## RESOLUTION NO. CR-16-20

### A RESOLUTION TO APPROVE THE DEVELOPMENT PLAN FOR FARMSTEAD SUB AREA H LOCATED AT 62 JACKSON PIKE

## ITEM 5: 202003040010 – Farmstead Subarea H (Development Plan)

**Subject: Farmstead Sub-Area H - Final Development Plan**

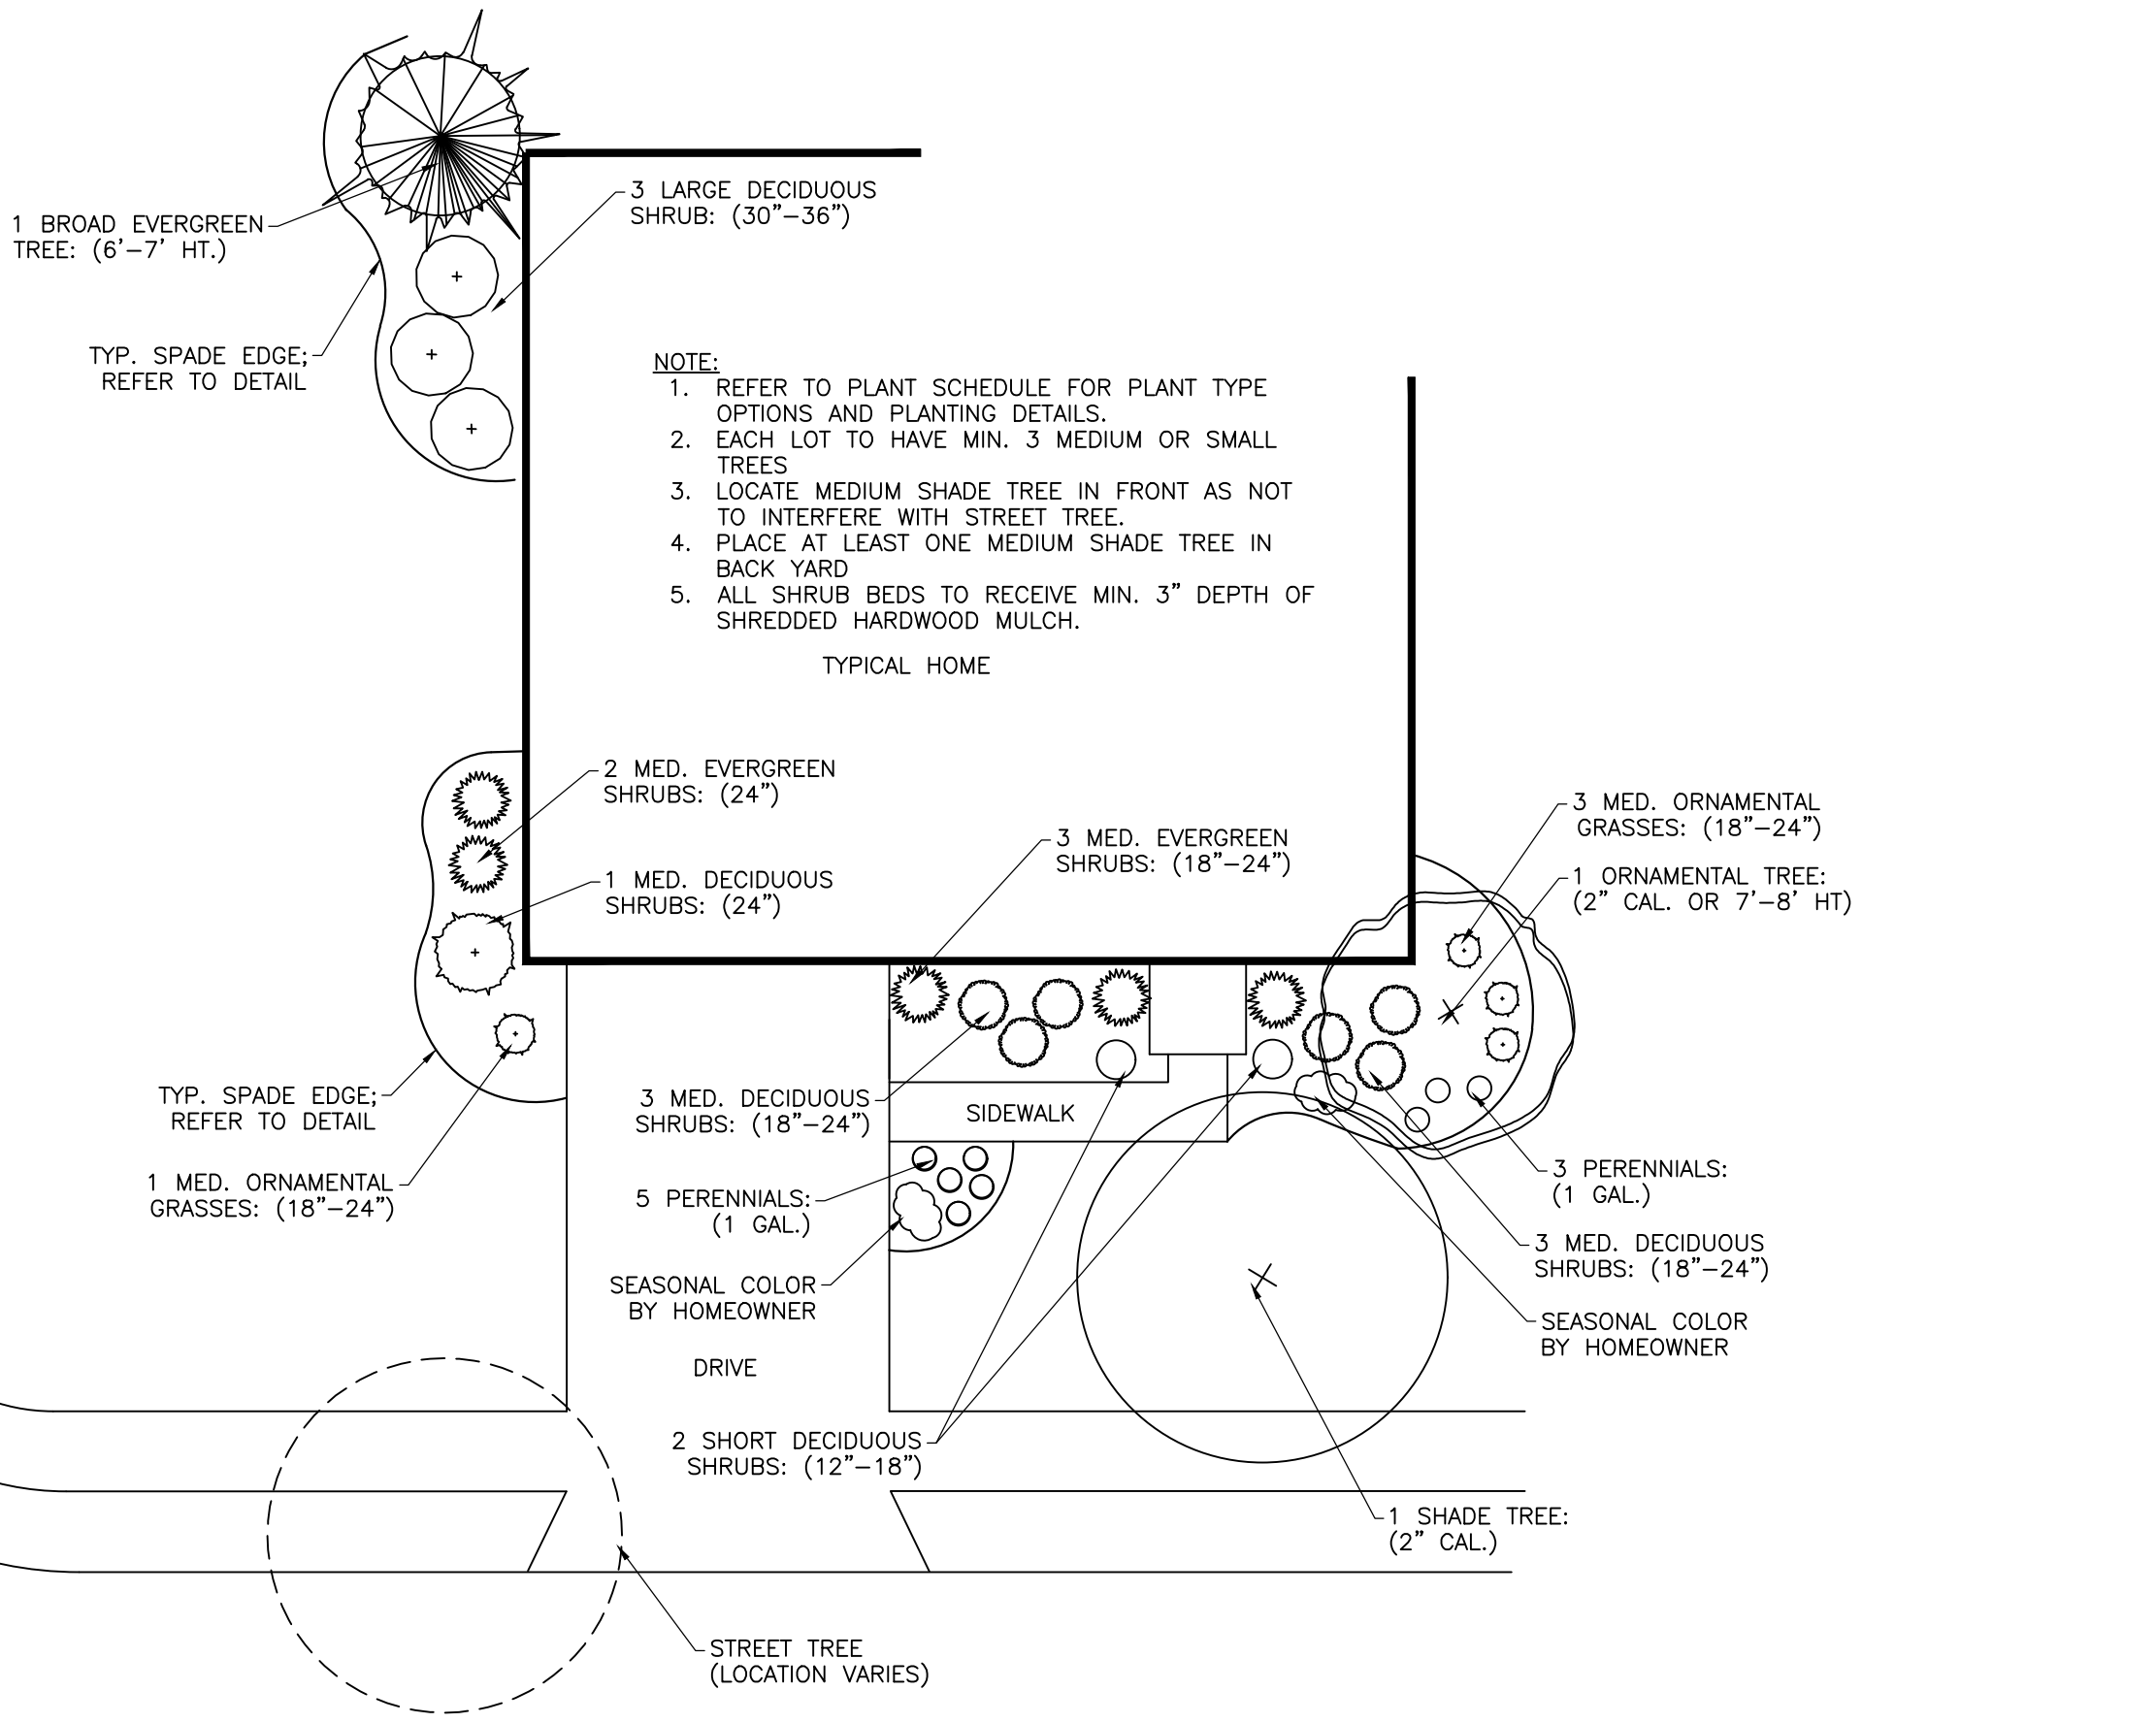
**This will be protected by silt fence once construction documents are produced.**
7. Tree Planting Typical on page C701 still states that 4" (inches) of shredded bark mulch is to be used. This should be corrected to state 2-3" (inches).

**All details have been updated; Refer to sheet C701**
8. Please provide a landscaping detail for landscaping that will be provided around the base of each CBU.

**A typical detail for the CBU has been added on sheet C701, and is consistent with the Farmstead Development.**
9. An updated version of Note #1 of Individual Parcel Note still requires correction. Pages C700 and C702 are not consistent, as note #1 for The Individual Parcel notes; page C702 lists as #2.

TYPICAL SINGLE HOME LANDSCAPE PLAN

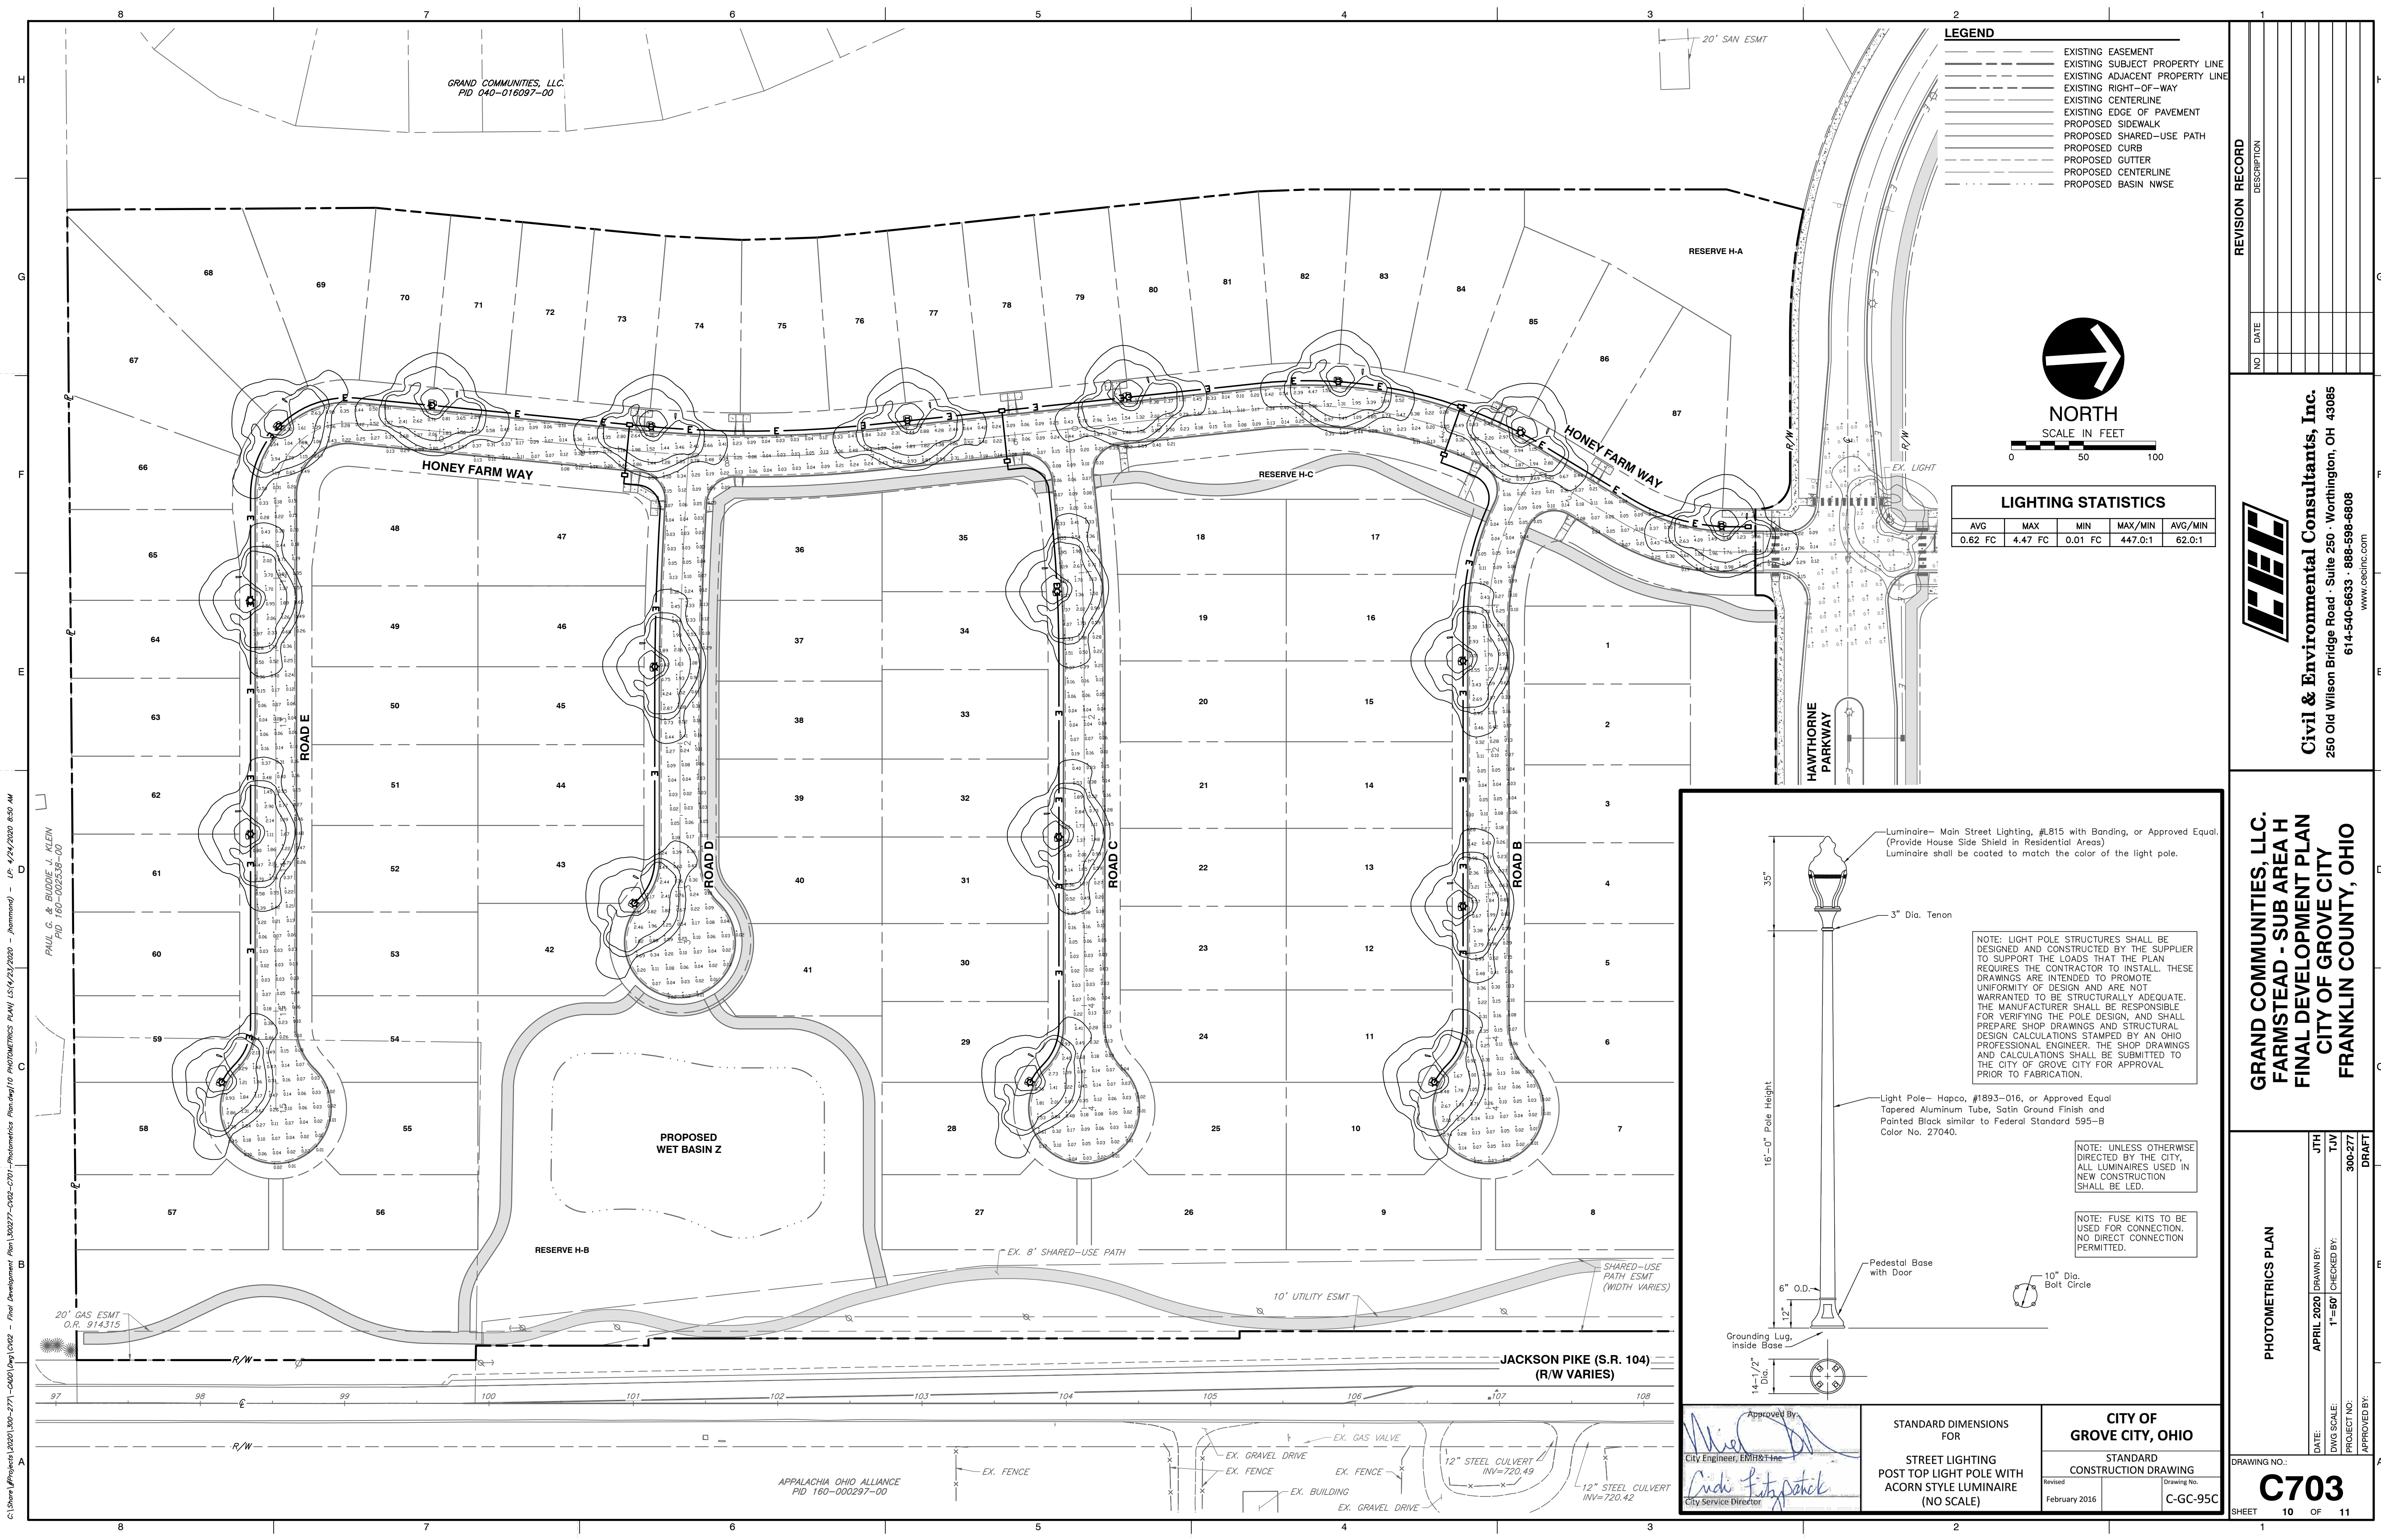
**All general notes have been updated and are now similar on both pages C700 & C702.**
10. All lots appear to be large enough to have 3 trees planted on them (street trees do not go towards this count, they are in addition to the 3 required per lot). Please state the lots you feel are not large enough for 3 trees and then show on landscape plan where these trees would be planted in the open area by labeling them with the associated Lot #.

**The Individual Parcel Note #2 has been corrected to indicate all 3 trees shall be planted on the Lot. Min. 1 tree in the front yard.**
